Town of Brunswick

Committee:	Staff Review Committee		
Date of Meeting:	12/10/2025	Time:	10:00 AM
Minutes Prepared By:	Susan Karnes, Administrative Floater	Location:	Town Hall, Council Chambers / Zoom
1. Purpose of Meeting (<i>Weekly meeting, Training, Workshop, etc....</i>)			
Weekly meeting

3. Meeting Agenda
<p>1. Case No. 25-059 – MaineHealth Mid Coast Cancer Center Renovation: The Staff Review Committee will review and make a recommendation to the Planning Board on a Site Plan Amendment application submitted by Pine Tree Engineering on behalf of the property owner, Mid Coast Health Services, for two one-story additions and the renovation of the existing building and parking area. The subject property is located at 81 Medical Center Drive (Map 45, Lot 32, 32-1) and within the Growth Mixed-Use 8 (GM8) Zoning District, and the Shoreland Protection Overlay (SPO), Shoreland Protection Overlay – Stream Protection (SPO-SP), Shoreland Protection Overlay – Resource Protection (SPO-RP), Rural Protection Stormwater Management Overlay (RPSMO), Flood Protection Overlay (FPO), Wetland Protection Overlay (WPO), and Cook’s Corner Overlay (CCO) subdistricts. The proposed location of developmen

SHEET TITLE AND NUMBER:
AS0.10
EXISTING
CONDITIONS PLAN

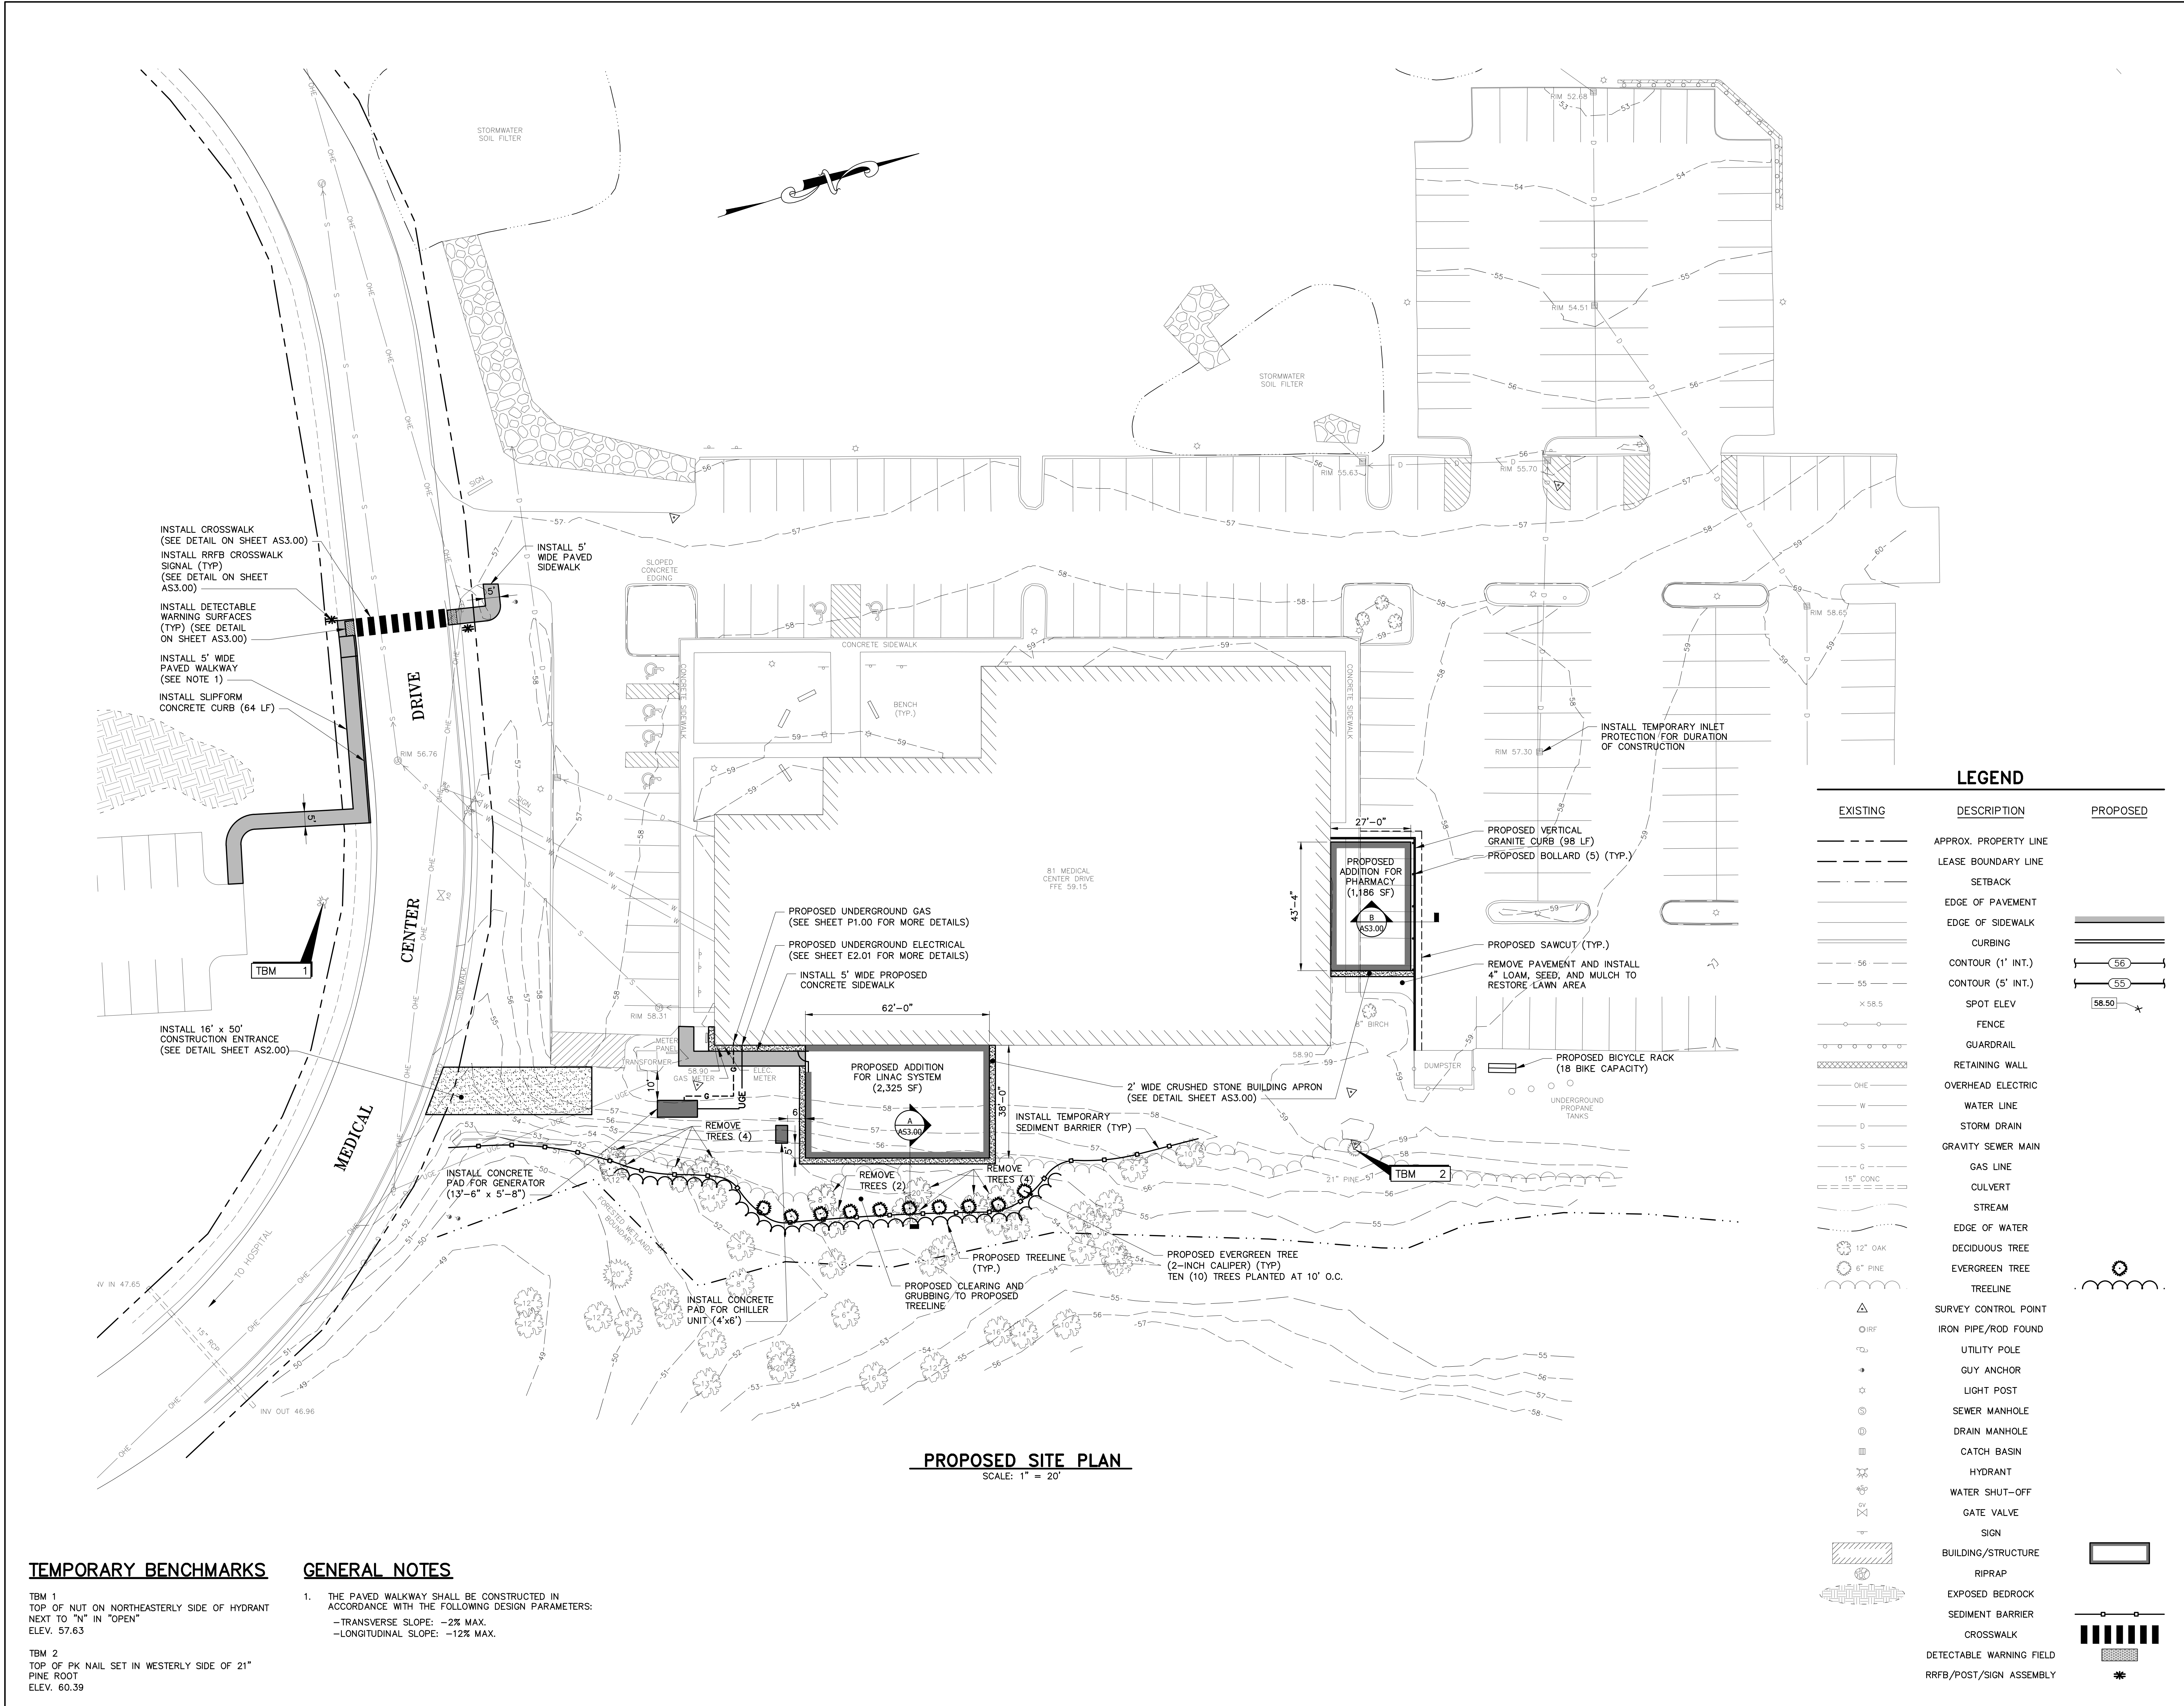
Ashley Charleson: I believe it's page 70 of the actual packet, but under 4.3.1 for the mapping of natural and historic areas requirements. In your packet, it indicates that these features are displayed on the existing conditions site plan and the legend reads or references the stream and edge of waterline on site. But from what I saw, this is the extent to what I assume is the wetland delineation and mapping of national areas that you're referring to.

The Existing Conditions Plan (AS0.10) in Exhibit 10 shows existing features on site. The boundary of forested wetlands was located east of the proposed building additions during a wetland delineation survey (on file with the Town from previous applications). The proposed building additions have been designed to avoid impacting any applicable features to the greatest extent practicable.

SHEET TITLE AND NUMBER:
AS1.00
PROPOSED SITE PLAN

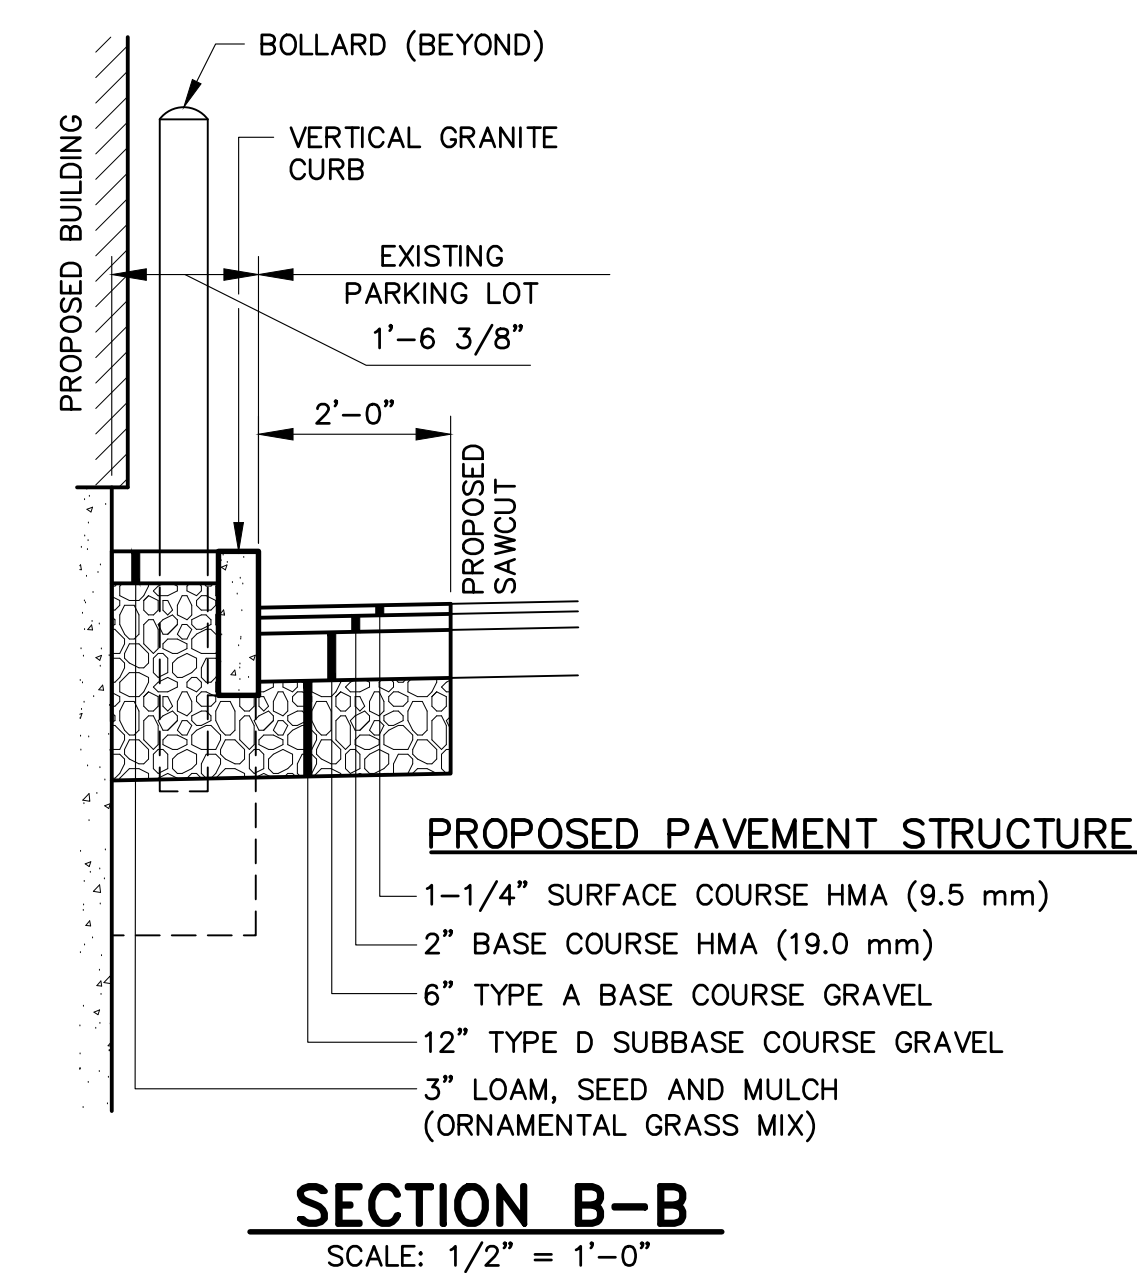
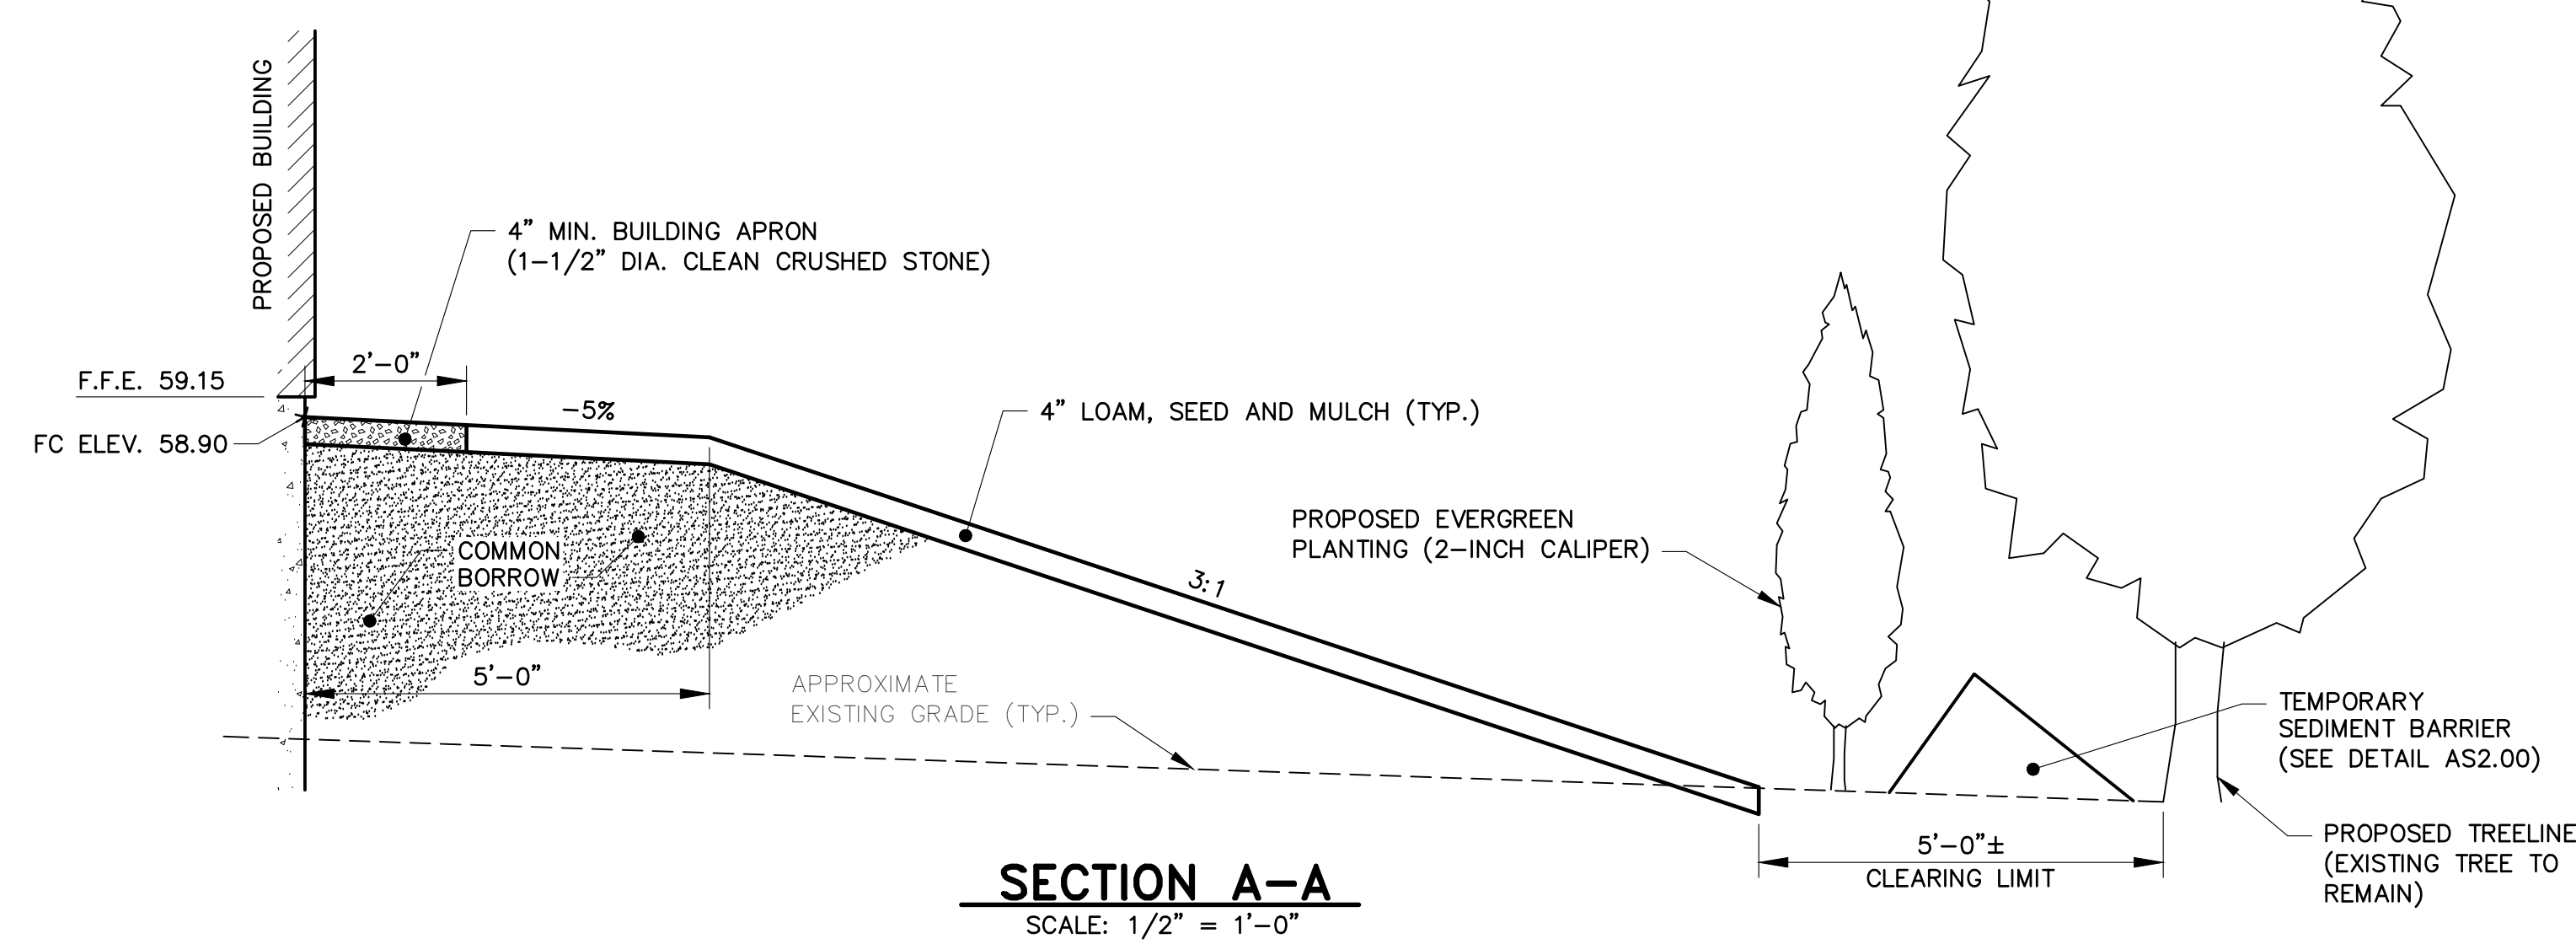
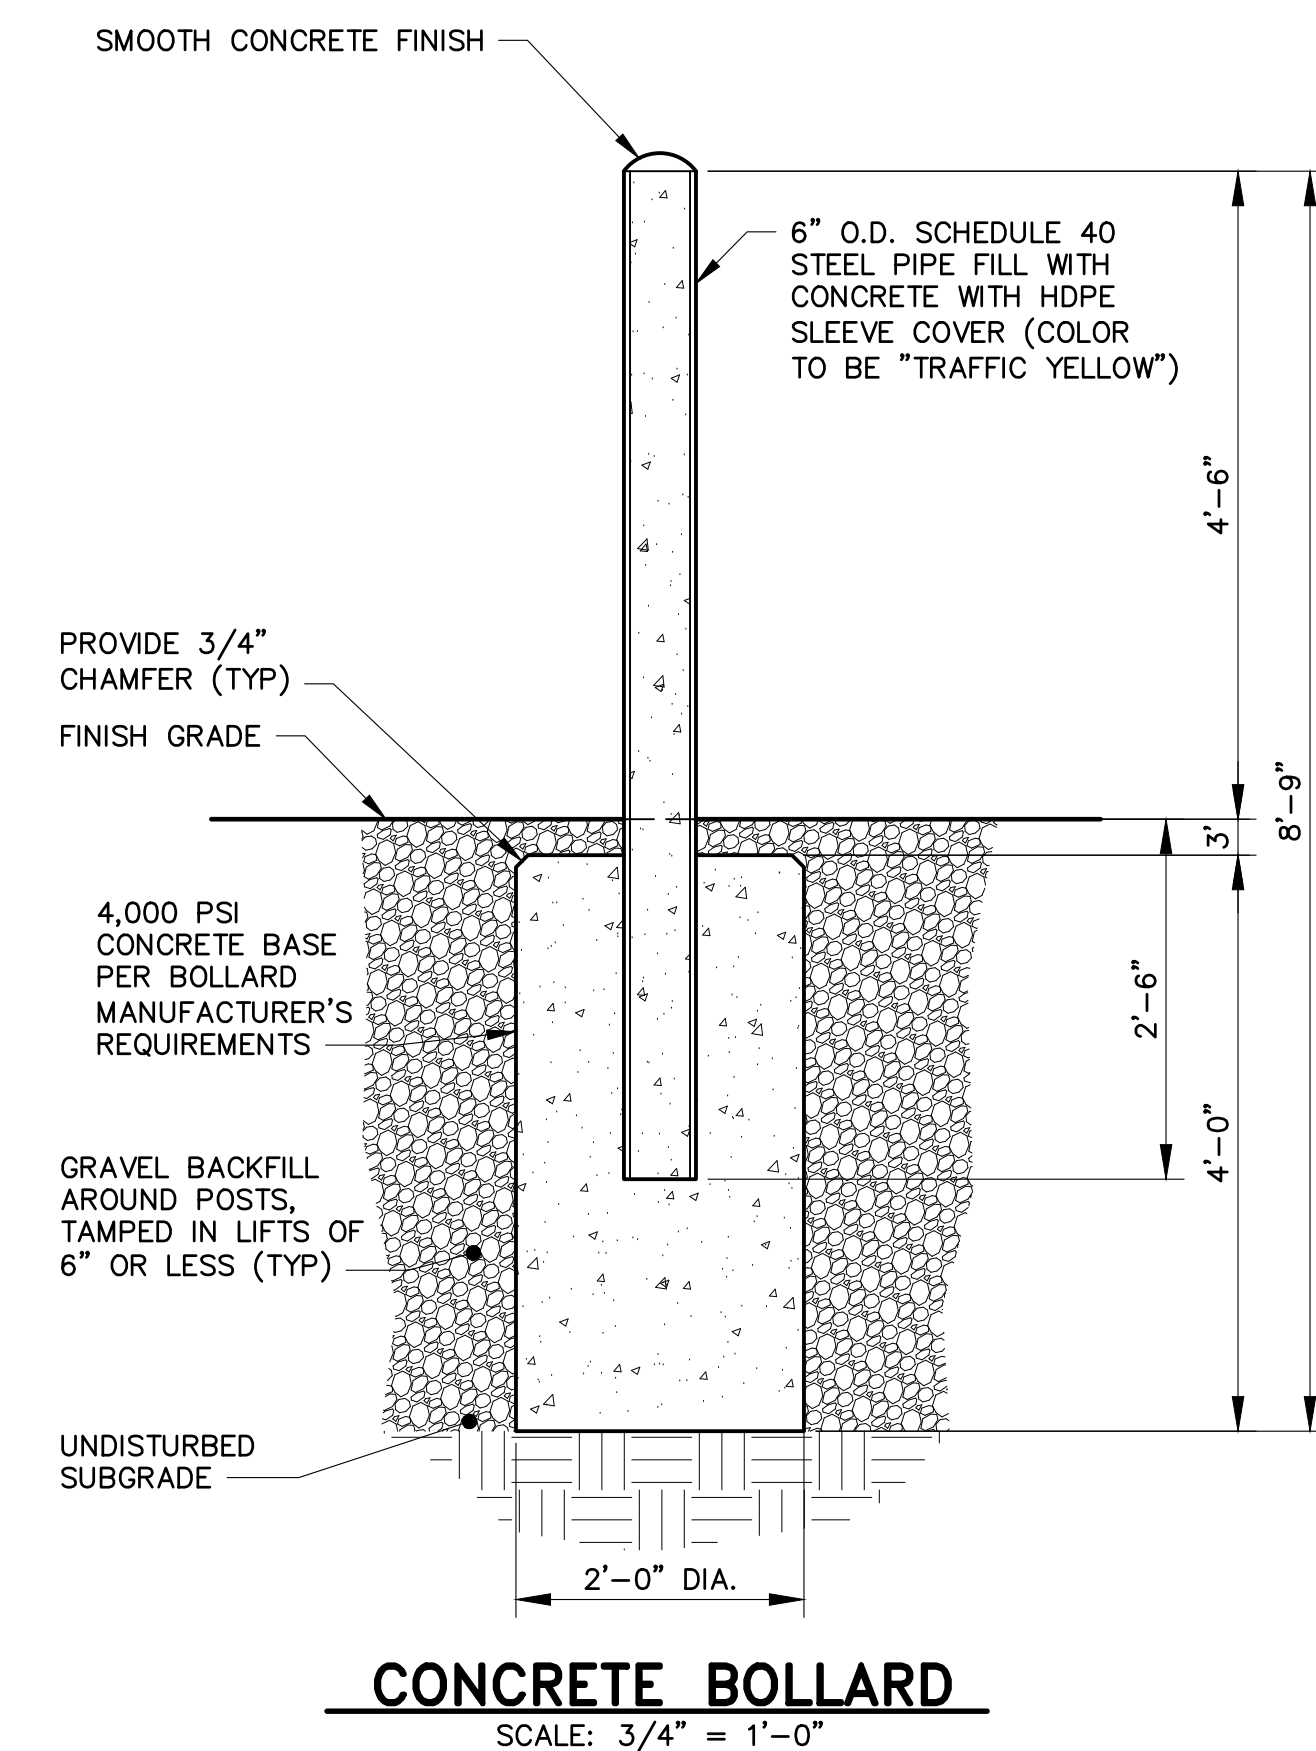
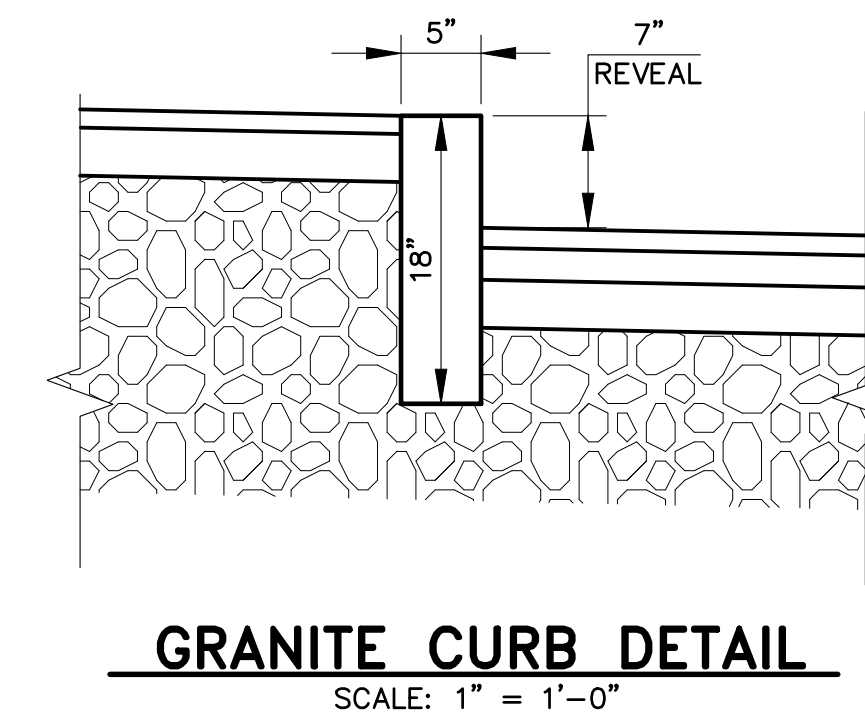
Landscaping Comments	Applicant Response
1. Add 10 evergreen trees at 10' o.c. spacing along proposed treelines	The proposed trees have been added to AS1.00 Proposed Site Plan.

6. Add Erosion Control Barrier linework to plans	Linework for the temporary sediment barrier has been added to AS1.00 Proposed Site Plan.
7. Add bicycle rack locations and callouts to plan (min. 13 spaces)	The proposed bicycle rack has been added to AS1.00 Proposed

Site Plan.
8. Add callouts for sediment sack to inlets	A callout for Temporary inlet protection has been added to AS1.00 Proposed Site Plan
General Comments
